A12 Chelmsford to A120 widening Supplementary consultation November 2021

Why are we having a supplementary consultation?

Junction 21 – southern link road removal

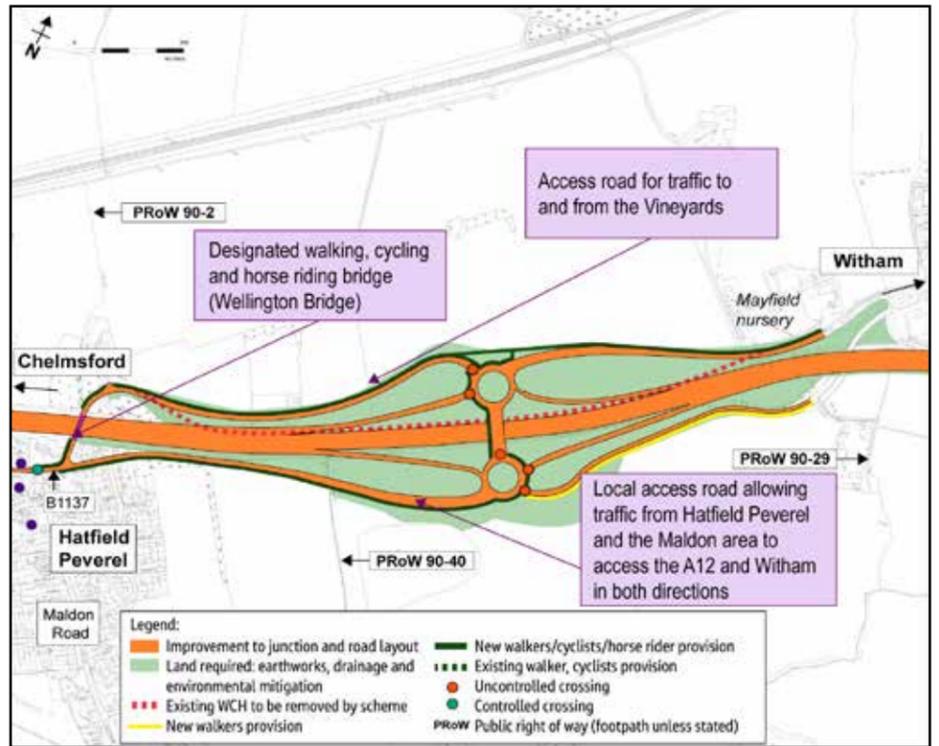
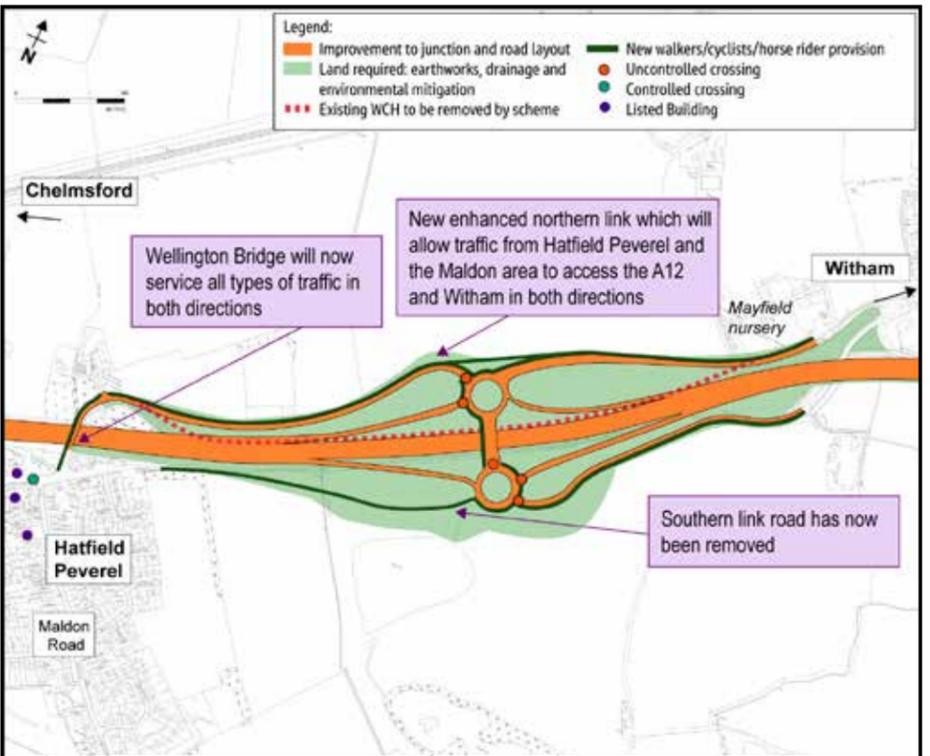
At statutory consultation we showed that traffic coming from the Hatfield Peverel and Maldon areas, via Maldon Road and the eastern end of The Street, would join the new junction 21 via a southern link road. Wellington Bridge was to be converted into a designated walking cycling and horse-riding (WCH) route. Properties to the north side of the bridge (The Vineyards) would have been able to access junction 21 via an access road. This can be seen in the map below.

In response to the statutory consultation, we have done a further review of the design at this location. Feedback from the statutory consultation suggested removing the previously proposed southern link road, and opening Wellington Bridge in both directions for all traffic to and from Hatfield Peverel and Maldon Road. This traffic would then use an enhanced northern link road (previously only serving The Vineyards) to access junction 21. Concerns were also raised about the environmental impact of the southern link on properties on the east section of The Street and it was felt by some who responded to the statutory consultation that removing the southern link road would address this.

In accordance with the feedback we received, and as shown in the map below, our updated design has removed the southern link road. Instead, traffic will use a new and enhanced northern link road to access our proposed junction 21. To allow this, Wellington Bridge will no longer only be a bridge for just WCH. It will now allow for all types of vehicles to travel both ways over it. To ensure WCH facilities are maintained, a route will be provided alongside the new connection to allow for the same WCH journeys we proposed as part of our statutory consultation. We will continue to work with Essex County Council and WCH stakeholders to develop the opportunities and welcome comments via this supplementary consultation.

Expected traffic numbers in Hatfield Peverel with the updated design

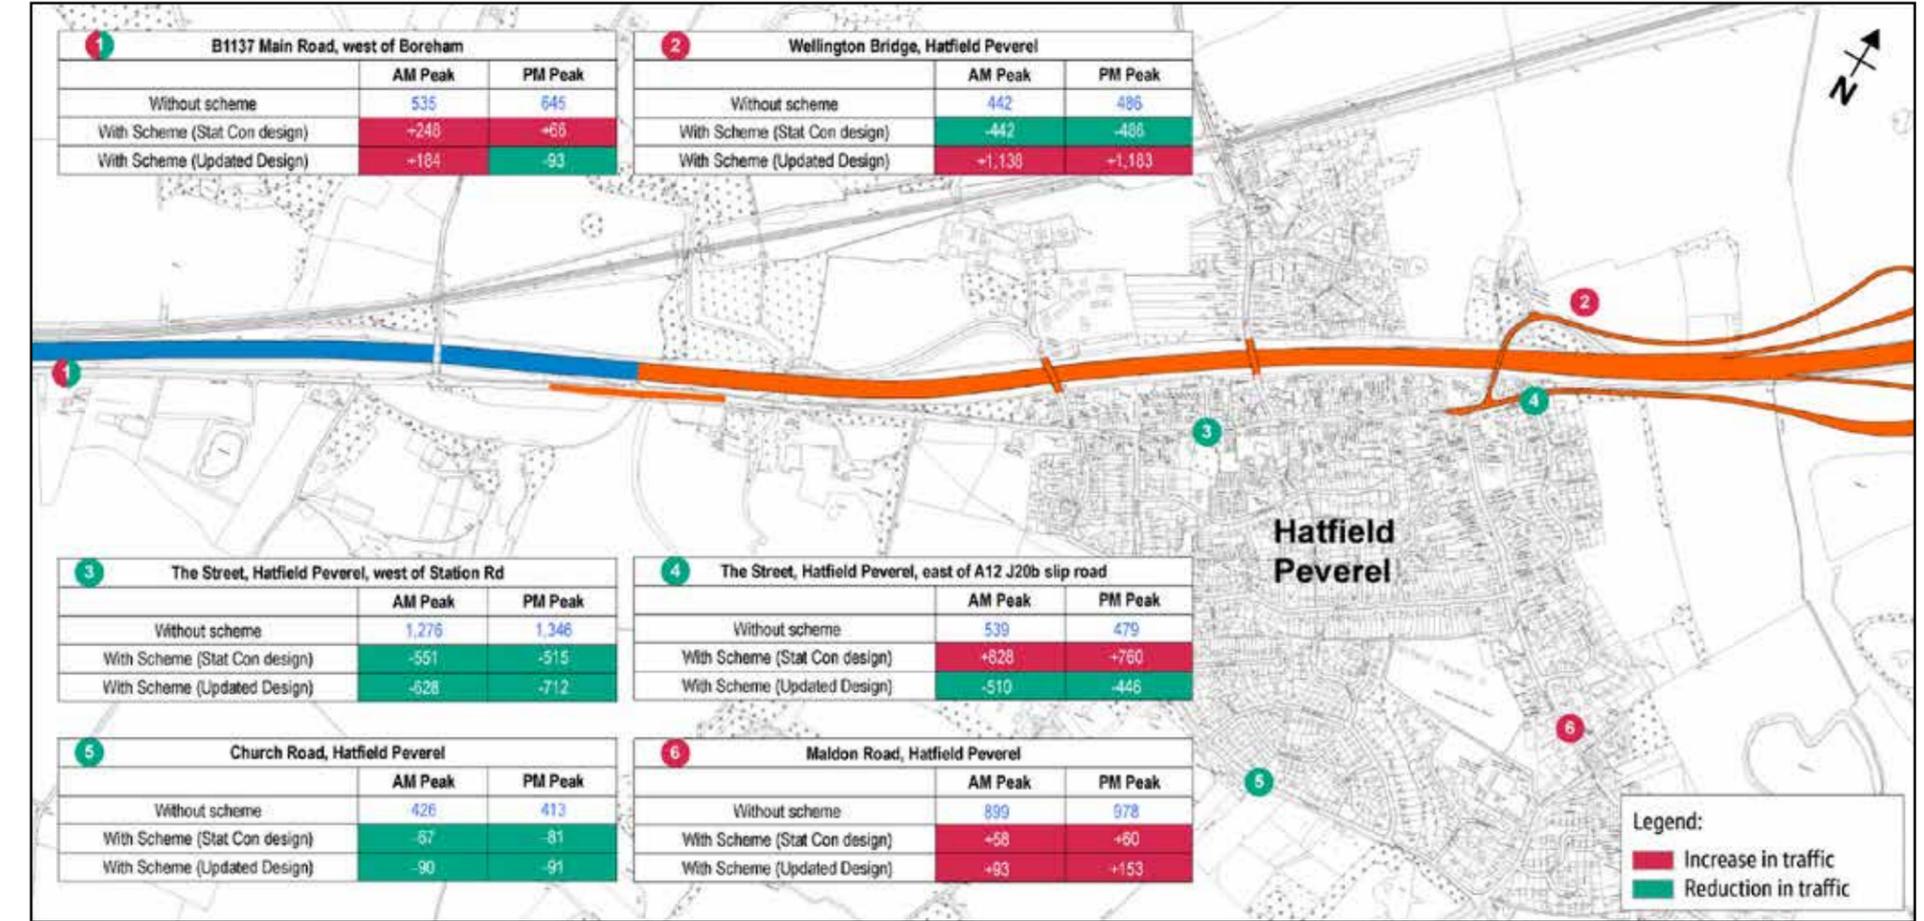
The map shows that traffic decreases considerably on the eastern end of The Street, but increases considerably on the new enhanced northern link road. The reduction on the central section of The Street is maintained, as are the predicted reductions on Church Road.

Predicted traffic on Main Road has also changed since the statutory consultation. This is due to the updated model, as well as our proposals to introduce new speed limits on the road. This proposal is confirmed in the category 2 changes on page 42.

Improved road surfacing and removal of noise barrier

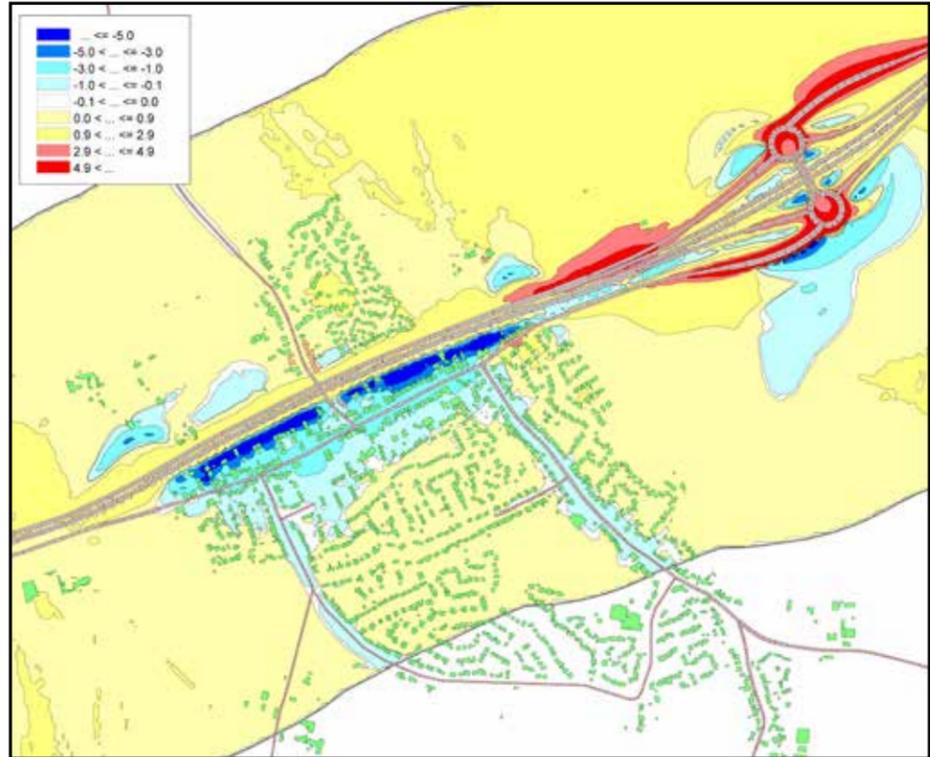
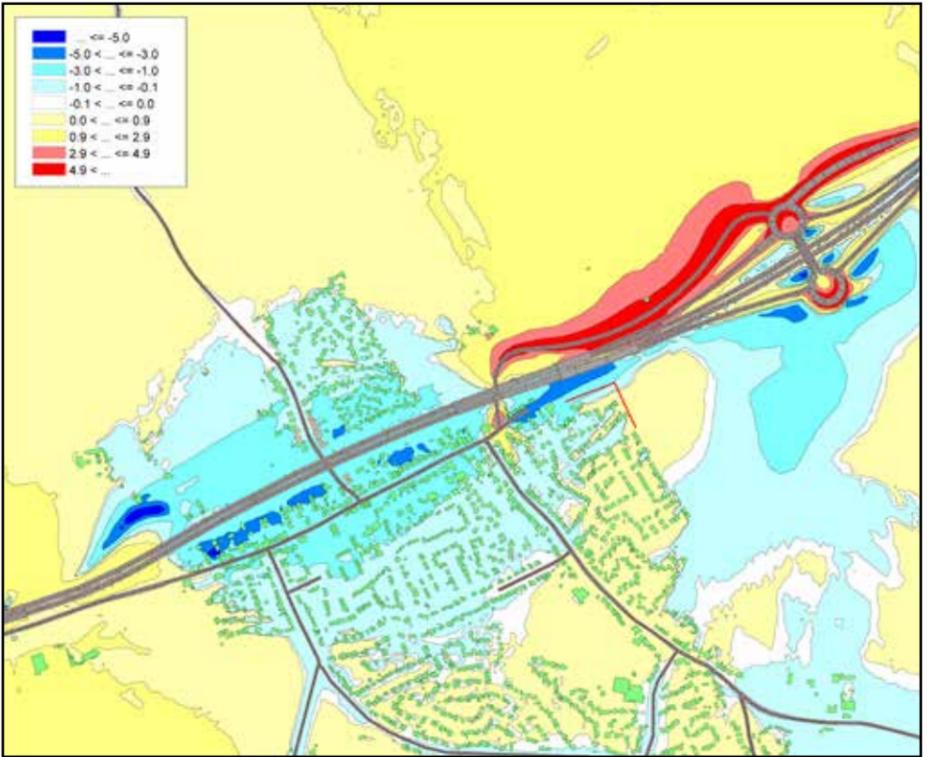
As shown in the map below, as part of the statutory consultation we proposed to build a 3 metre high noise barrier between the existing junctions 20a (Bury Lane) and 20b (Wellington Bridge), on the south side of the A12, as it runs through Hatfield Peverel. This proposal would have seen a noise reduction for homes in the village, predominantly to the south side of the A12.

We received lots of feedback on our proposals for a noise barrier during statutory consultation, with many responses asking that we consider better mitigation for houses on the northern side of the proposed scheme. We have considered this in more detail and are now proposing to provide road surfacing with better noise performance on the A12. This allows us to remove the noise barrier we were proposing on the southern side of the A12 while at the same time reducing noise levels for more properties than our statutory consultation design would have done, as well as reducing construction impacts. The noise maps on page 19 show the expected overall noise reduction that residents can expect with the improved road surfacing, compared to what we previously proposed with just the noise barrier. Above this, the height of the retaining wall required will be reduced.

Our new approach at this location will remove the noise barrier we presented at statutory consultation and use improved road surfacing to mitigate noise impacts. Our approach will also:

- reduce the height of the retaining wall
- reduce the depth underground to which the retaining structure needs to be installed, meaning there will be a shorter construction period required and less construction noise for residents
- reduces the disruption associated with installation

Potential route corridors identified for diversion

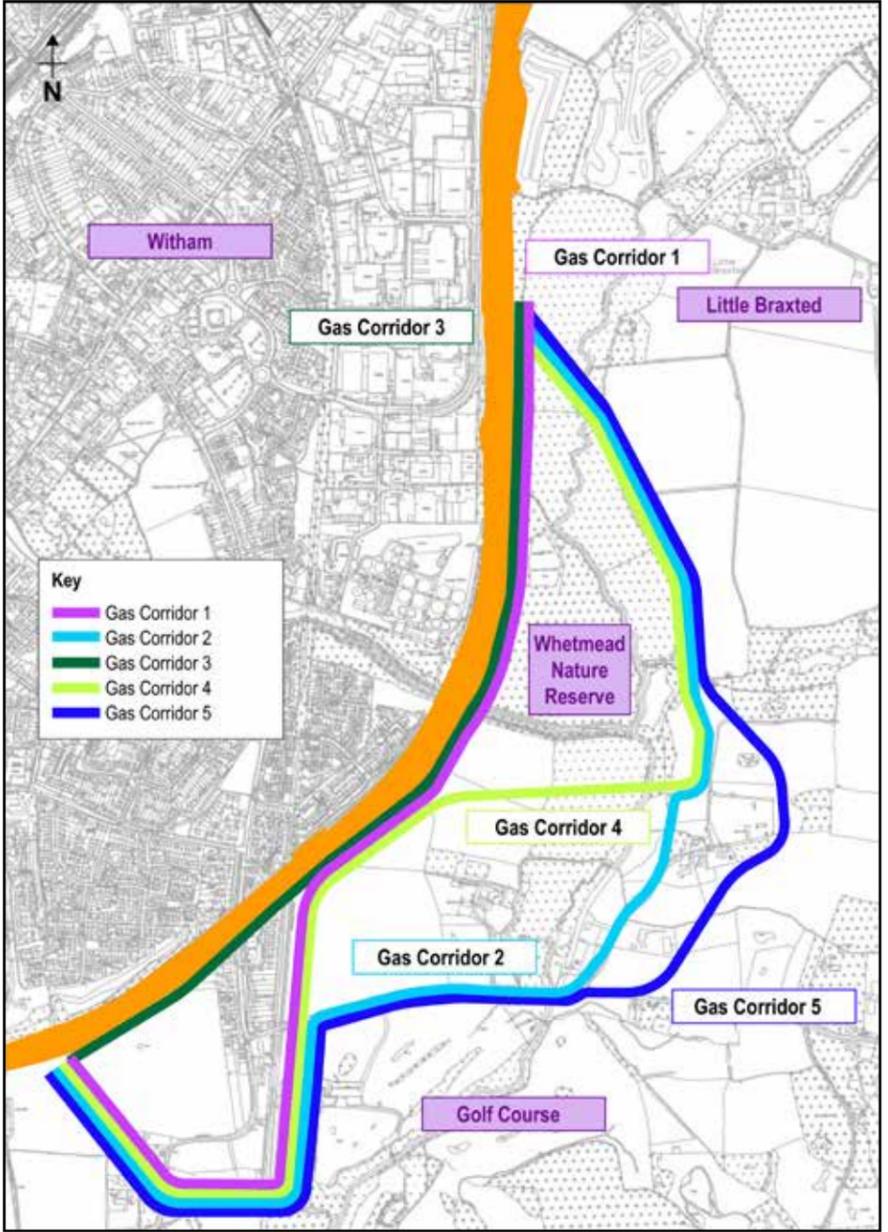
At statutory consultation, while we mentioned the possibility of a high-pressure gas main diversion being required, we had not completed the necessary work to understand the extent of the gas main, whether it would require a diversion and where the diversion may go.

We have carried out further work on possible corridors which could accommodate this pipeline. This work has identified five corridor options where the gas main could be diverted. As part of the proposed scheme, we will need to reroute part of the high pressure gas pipeline. We are therefore asking for your opinions on each of the possible diversion corridors. It is important to note that the decision on which route which will be taken forward will be a decision for Cadent Gas Limited who operate and maintain the gas distribution network, but your comments could influence the decision that they make.

The adjacent image shows the five potential identified route corridors. Only one of these corridors would be needed and therefore constructed.

Corridors 1 and 3 would be our preferred routes as they broadly run alongside the proposed scheme, and therefore have less impacts on the surrounding area. Corridors 2, 4 and 5 were designed to provide alternative options whilst providing sufficient width to reduce impacts on properties, businesses and ecologically sensitive areas (including a nature reserve) where possible.

Construction space required for gas corridor diversions

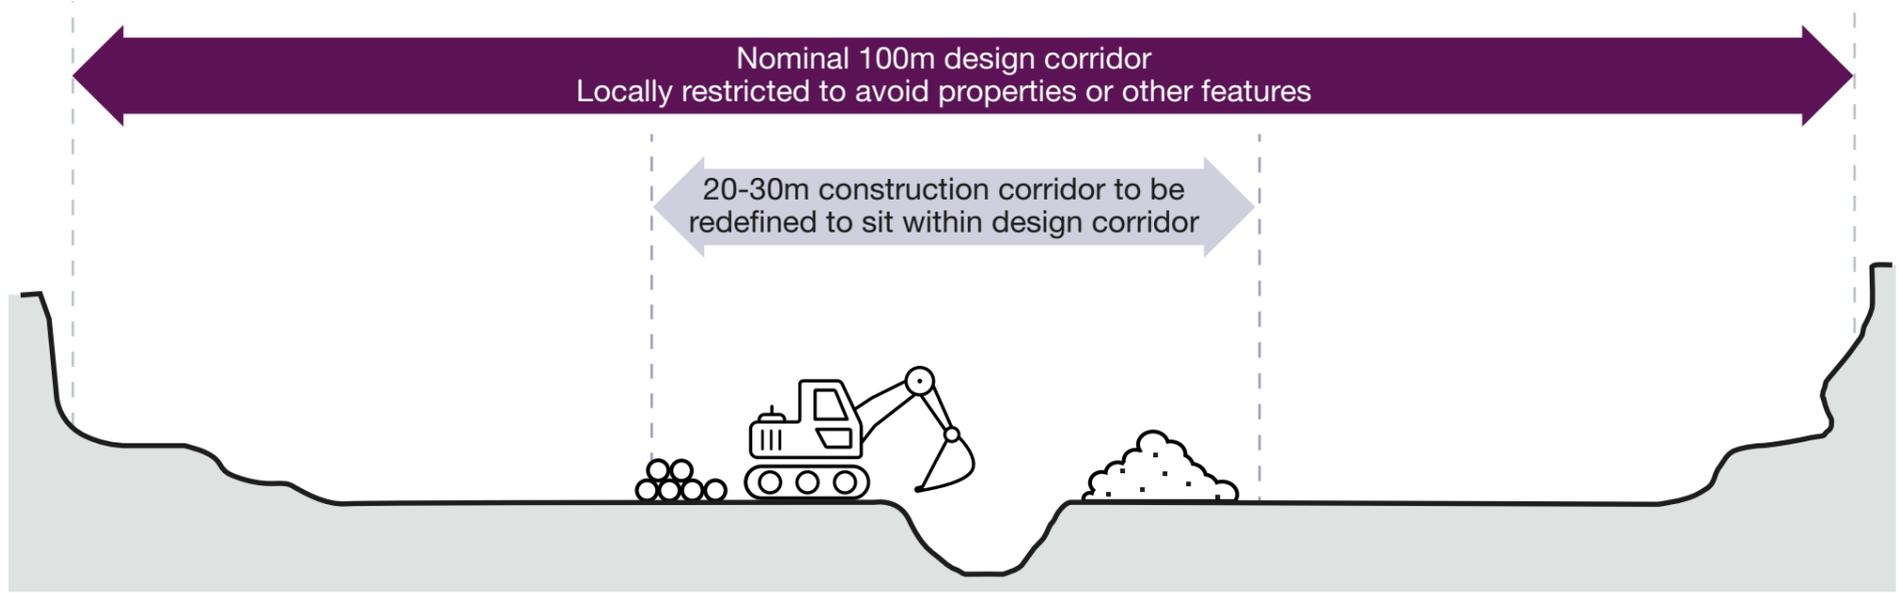
In order to undertake the work, a working corridor will be required of approximately 20 to 30 metres. This would allow us to dig trenches, store the excavated material next to the trench and receive deliveries safely. A fence would also be required during the construction period to manage access to the working area and keep everyone safe.

The indicative image below shows a breakdown of how the space may be used during construction. This would be the approach no matter which corridor is constructed.

Intervention measures on Inworth Road

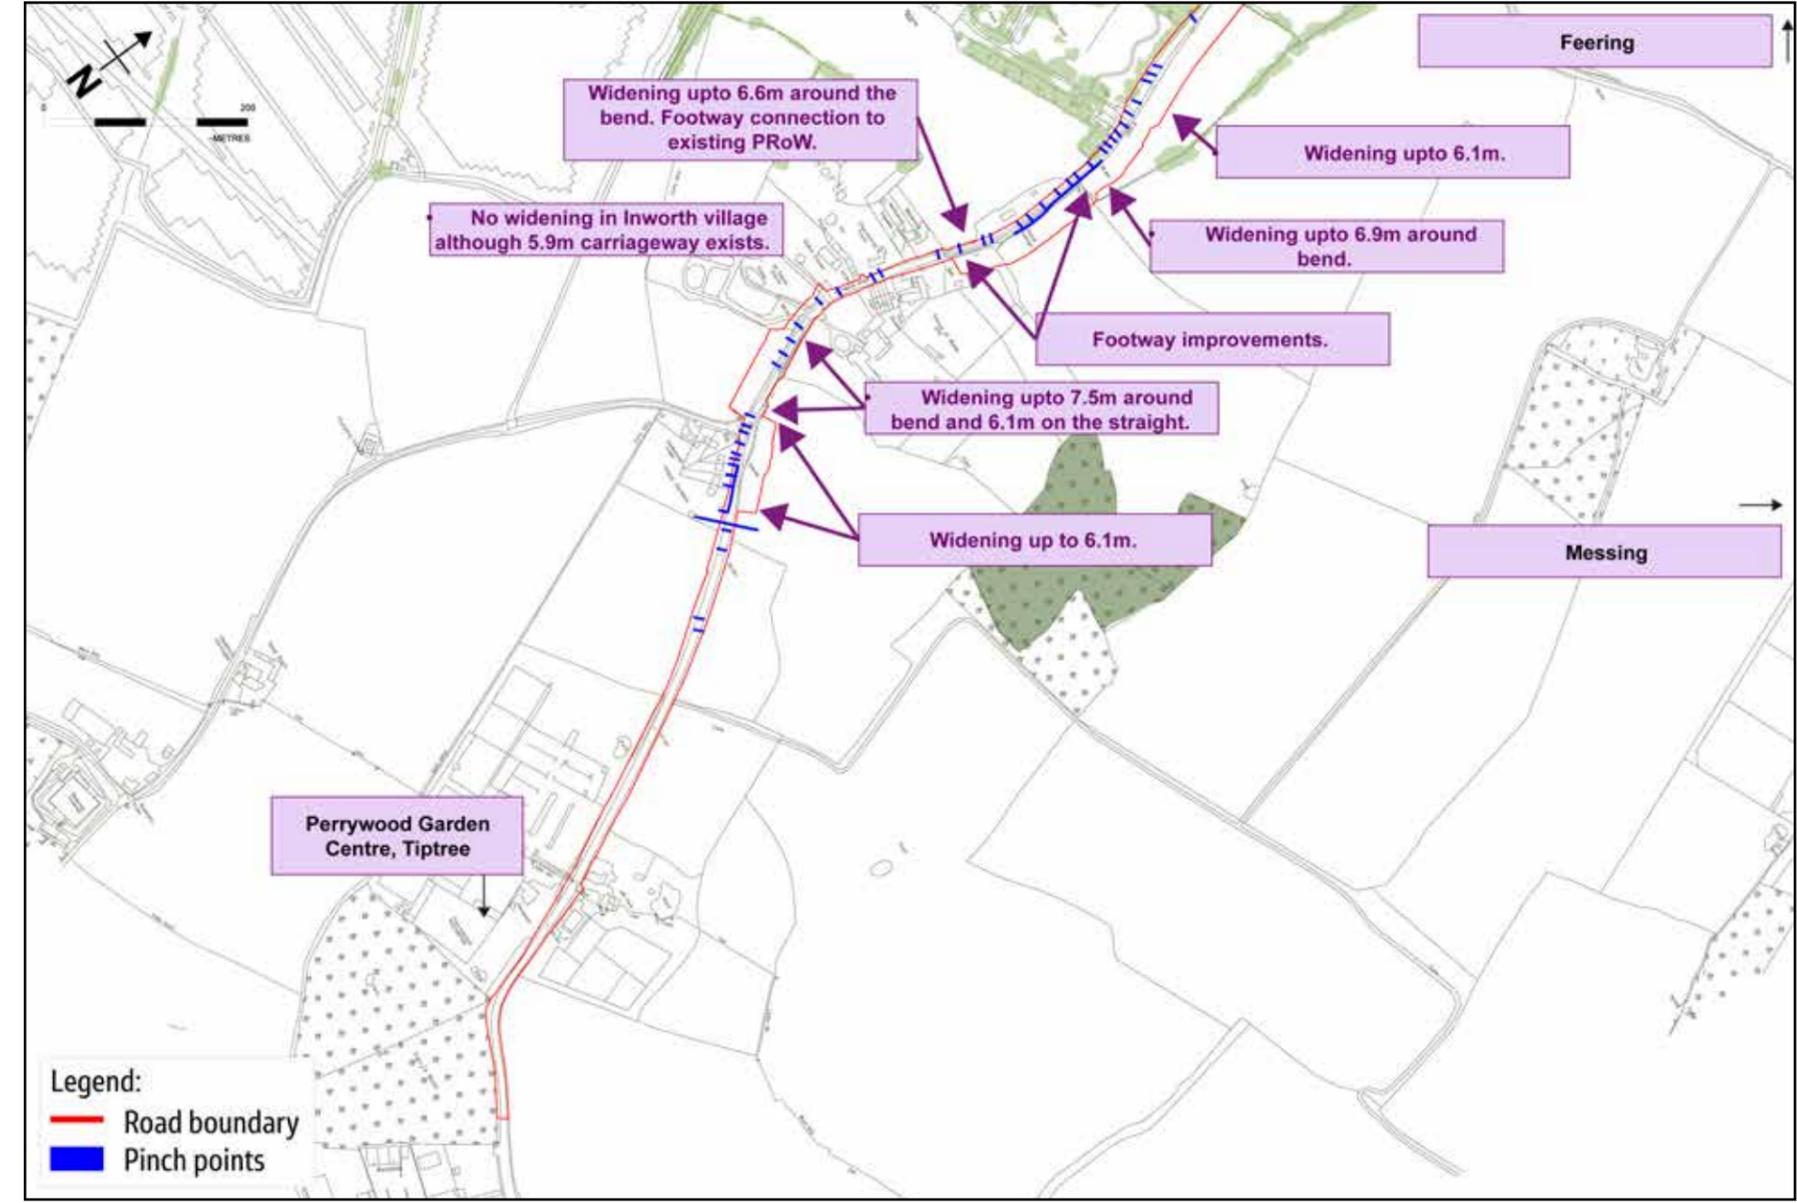
Since our statutory consultation, design work has advanced, and we have completed a traffic and drainage assessment. This has allowed us to present a design that will ensure that the additional traffic does not lead to increased delays on the road, and also addresses some of the safety and flooding concerns raised by stakeholders.

We are proposing to widen certain pinch points along Inworth Road by between 0.3m and 2m. This includes widening straight sections of the road to provide a minimum of 6.1m carriageway width and widening bends to accommodate two large vehicles passing in opposite directions. Where we make these changes, we will also provide new drainage.

A detailed technical assessment has taken place to consider what interventions are required to ensure that Inworth Road can manage the increase in traffic, and these are explained in the diagram on page 29. The interventions will require some flood mitigation. Several flood and drainage mitigation areas have been proposed, these can be found in **Map book 1 – updated general arrangements (set 3): sheets 14 and 20.**
